TRANS/WP.29/GRE/2002/37  
18 July 2002

World Forum for Harmonization of Vehicle Regulations (WP.29)

PROPOSAL FOR DRAFT AMENDMENTS TO REGULATION NO. 113

Transmitted by the Expert  
from the International Motorcycle Manufacturers Association (IMMA)

Figure 11

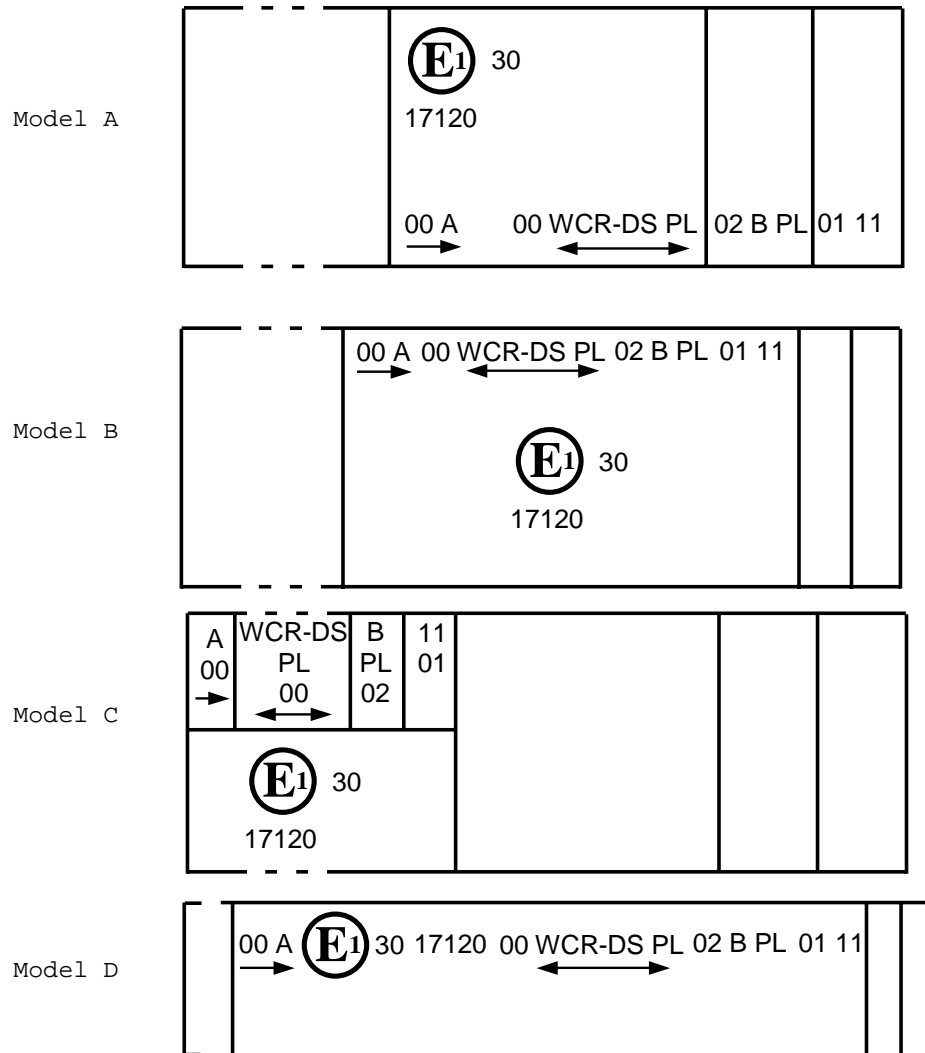
- 4.3.2.5. Annex 2, figure 11, to this Regulation gives examples of arrangements of approval marks for grouped, combined or reciprocally incorporated lamps with all the above-mentioned additional symbols.

Note: The four examples above correspond to a lighting device bearing an approval mark comprising:

A headlamp, Class D, with a passing beam and a driving beam with a maximum intensity comprised between 86 250 and 101 250 candelas (as indicated by the number 30), approved in accordance with the requirements of this Regulation in its original form (00) and incorporating a lens of plastic material,

Figure 12

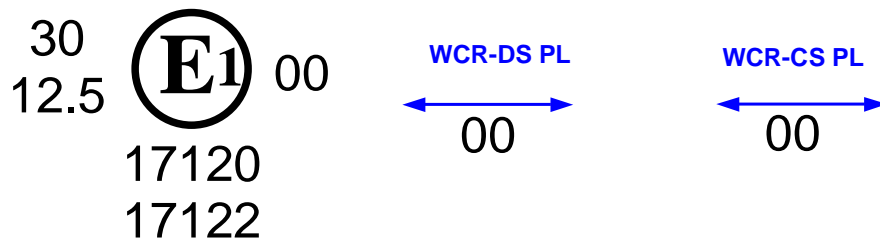
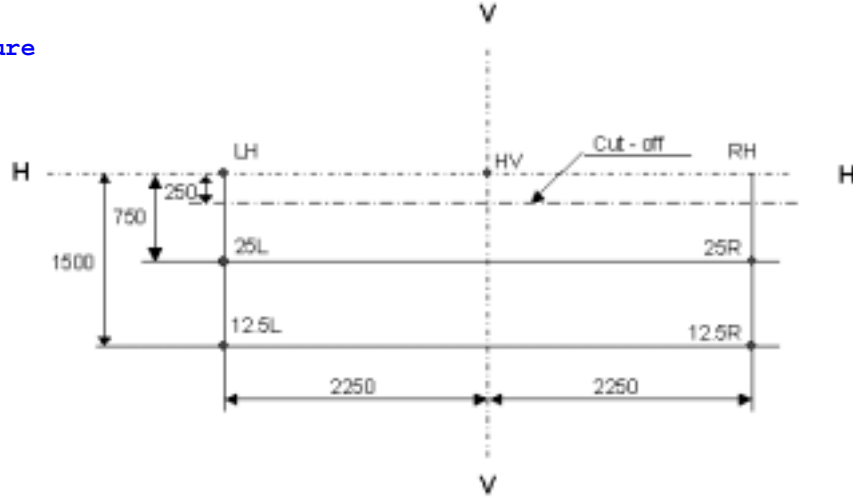
- 4.3.3.2. Annex 2, figure 12, to this Regulation gives examples of arrangements of approval marks relating to the above case."

The above example corresponds to the marking of a lens of plastic material intended to be used in different types of headlamps, namely:

Either A headlamp, Class D, with a passing and a driving beam with a maximum luminous intensity comprised between 86 250 and 101 250 candelas (as indicated by the number 30), approved in Germany (E1) in accordance with the requirements of this Regulation in its original form (00), which is reciprocally incorporated with a front position lamp approved in accordance with the 00 series of amendments to Regulation No. 50;

Or A headlamp, Class C, with a passing beam and a driving beam with a maximum luminous intensity comprised between 33 750 cd and 45 000 cd (as indicated by the number 12.5), approved in Germany (E1) in accordance with the requirements of this Regulation in its original form (00), which is reciprocally incorporated with the same front position lamp as above;"

Figure C

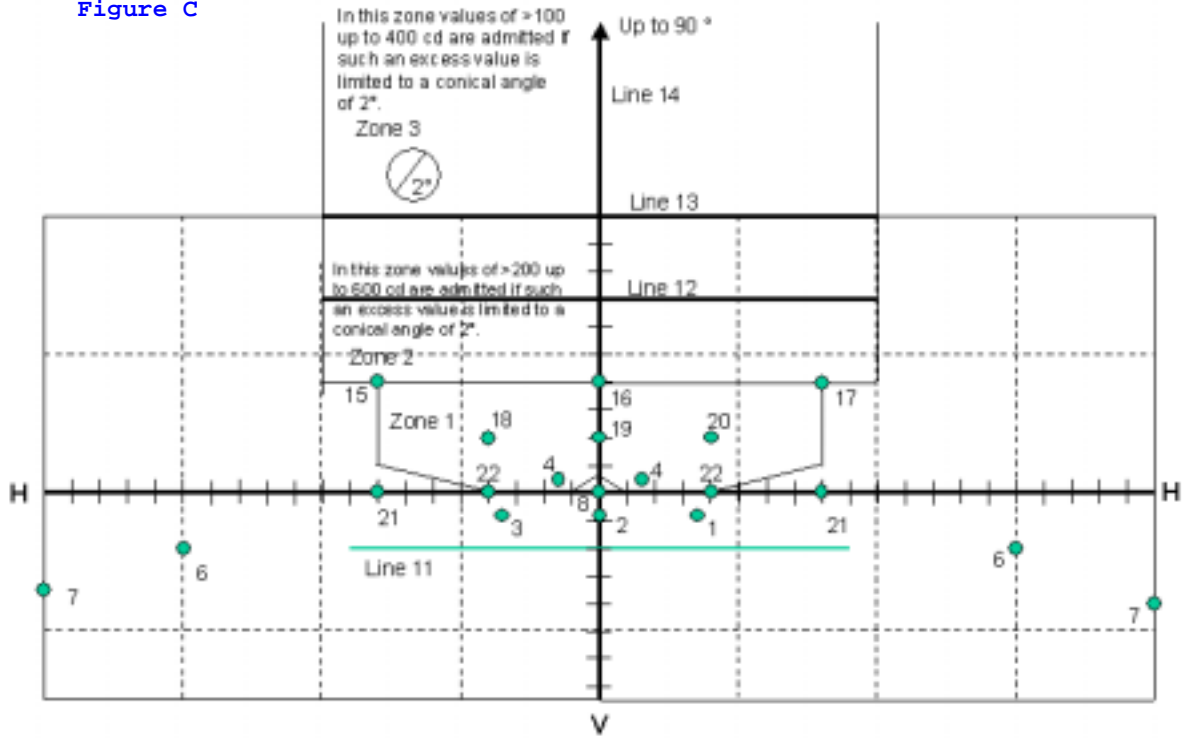
MEASURING SCREEN  
for Class C and D headlamps  
(Dimensions in mm with screen at 25 m distance)

FIGURE D  
Primary Driving Beam

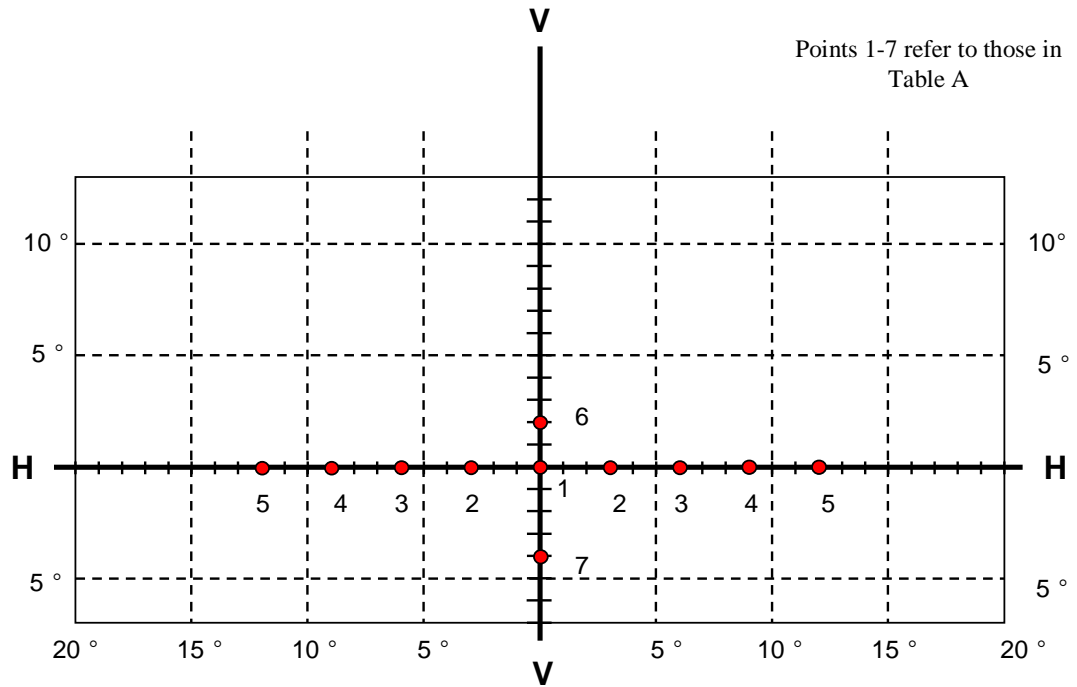
Refer to Figure D for details of test point positions

TEST POINT NUMBER	TEST POINT LOCATION	Required illumination in lux			
		Class D		Class C	
		> 125cc		125cc =>	
		MIN.	MAX.	MIN.	MAX.
1	H-V (1)	(1)	---	(1)	---
2	H-3R & 3L	19.2	---	12.8	---
3	H-6R & 6L	6.4	---	4.16	---
4	H-9R & 9L	3.84	---	2.56	---
5	H-12R & 12L	1.28	---	0.8	---
6	2U-V	1.92	---	1.28	---
7	4D-V	---	(2)	---	(2)
	MIN. LUMINOUS INTENSITY OF THE MAXIMUM	51.2	---	32	---
	MAX. LUM. INTENSITY	---	180.0	---	180.0

- (1) Intensity at H-V shall be equal to or greater than 80 per cent of the maximum intensity in the beam pattern.
- (2) Intensity at 4D-V shall be equal to or less than 30 per cent of the maximum intensity in the beam pattern.

FIGURE E  
Secondary Driving Beam

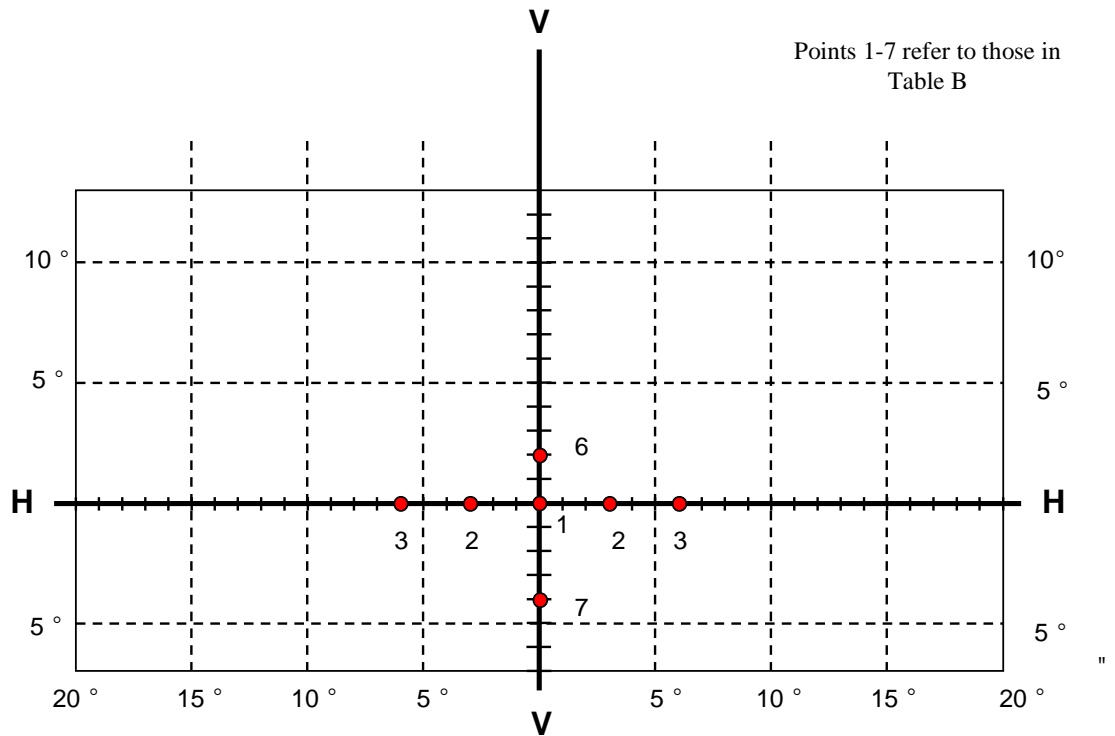
A. Refer to Figure E for details of test point positions

TEST POINT NUMBER	TEST POINT LOCATION	Required illumination in lux			
		Class D		Class C	
		> 125cc		125cc =>	
		MIN.	MAX.	MIN.	MAX.
1	H-V (1)	(1)	---	(1)	---
2	H-3R & 3L	19.2	---	12.8	---
3	H-6R & 6L	6.4	---	4.16	---
6	2U-V	1.92	---	1.28	---
7	4D-V	---	(2)	---	(2)
	MIN. LUMINOUS INTENSITY OF THE MAXIMUM	51.2	---	32	---
	MAX. LUM. INTENSITY	---	180.0 (3)	---	180.0 (3)

- (1) Intensity at H-V shall be equal to or greater than 80 per cent of the maximum intensity in the beam pattern.
- (2) Intensity at 4D-V shall be equal to or less than 30 per cent of the maximum intensity in the beam pattern.
